EXHIBIT A
RECOMMENDED CONDITIONS OF APPROVAL

Case PUD-82
4171 and 4189 Stanley Boulevard

SPECIAL CONDITIONS OF APPROVAL
Planning

PRELIMINARY SITE PLAN FROM
THE WORK SESSION **EXHIBIT F**

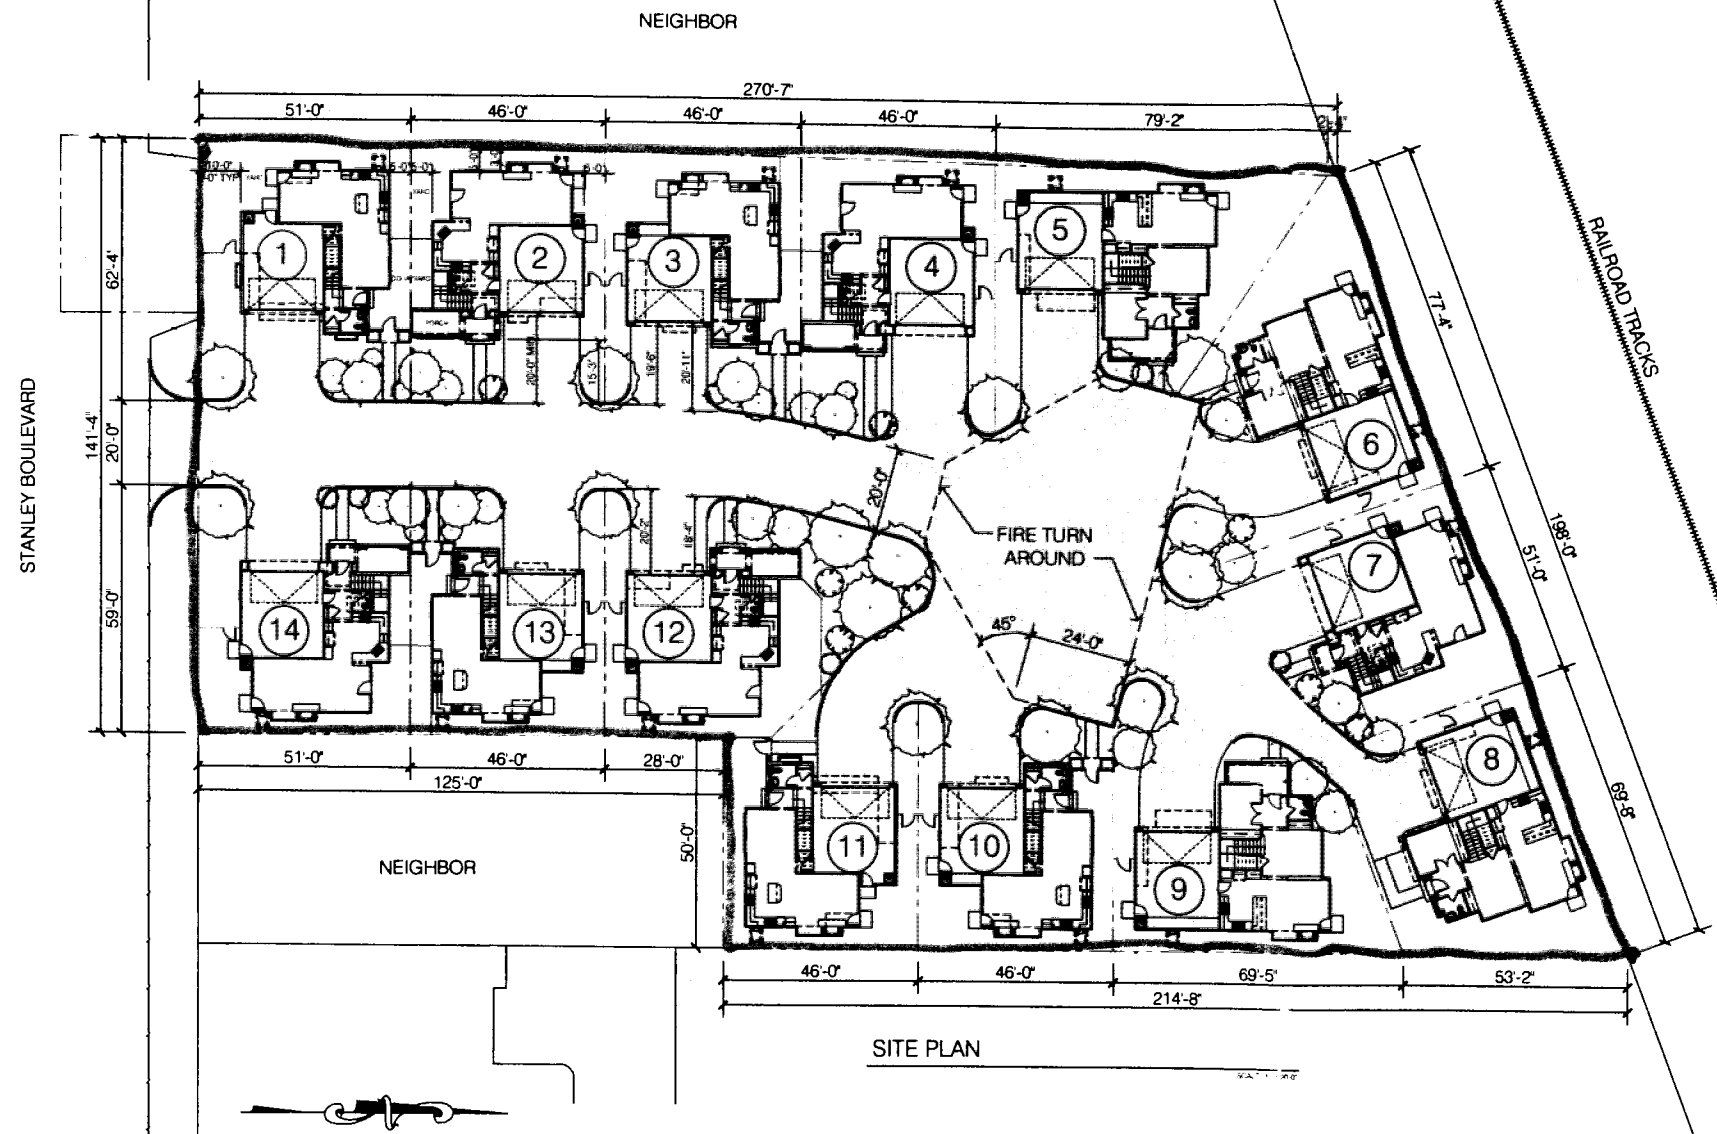
Commissioner Fox noted that the layout was unusual and that it did not appear to be a typical cul-de-sac configuration. She inquired whether the Pleasanton Heritage Association (PHA) was given notice on this item and whether it had any comments. Ms. Soo noted that the PHA had not been noticed. She added that staff was interested in the Commission's comments and that it was not a project that would need to go to the PHA for comments.

Ms. Decker noted that the fire turnaround evolved from the original application. She stated that the site plan originally came in for review with almost completely paved drive and common area with no landscaping. An effort had been made to provide additional landscaped area, and this particular proposal provided more landscaped areas. She noted that the hammerhead turnaround fit within it, and the amount of green space was optimized up to that turnaround. She noted that this proposal could be modified accordingly.

With regard to the lot on the east side, Commissioner Narum inquired about the setbacks of the townhouses (Lots 9-11) from the property line. Ms. Decker believed that the rear yard setback was three feet. Commissioner Narum inquired about the setback on the adjoining property and inquired whether there were six to seven feet between the houses to the rear and what lay behind them. Ms. Decker noted that staff would confirm those dimensions when the project returns to the Planning Commission. She noted that it appeared from the aerial that it looked to be approximately 15 to 20 feet to the property line but that it was not necessarily an accurate representation.

Commissioner Fox noted that in looking at Concept C, the plan view of the landscaping, it appeared to look different than the actual DR-2 site plan. She noted that it appeared that the fingers were tapered back and inquired whether Concept C was meant to be the same as the DR-2 site plan or whether it was the original concept. Chair Blank noted that the dates on the plans were 10/07 and 3/08 and suggested that the Commission ask that question of the applicant.

Commissioner Fox noted that the rear yard setback was three feet and inquired whether all the buildings were three feet from the fence. Mr. DiDonato noted that the setback to the buildings was five feet and that the three-foot dimension was to the media center, which was an encroachment into the setback as allowed by the City. Commissioner Fox inquired about the notation on page 3 of the staff report. Mr. DiDonato replied that technically, that was not correct because the setback for the project was five feet to the building; the distance from the property line to the media center or fireplace was three feet. He suggested that the City clarify its definition as to what the setback would be.

Ms. Decker noted that as the plans are developed more fully, staff will confirm what the dimension is and whether it would be based on the midpoint or the ridge. She added that staff will return with the appropriate information.
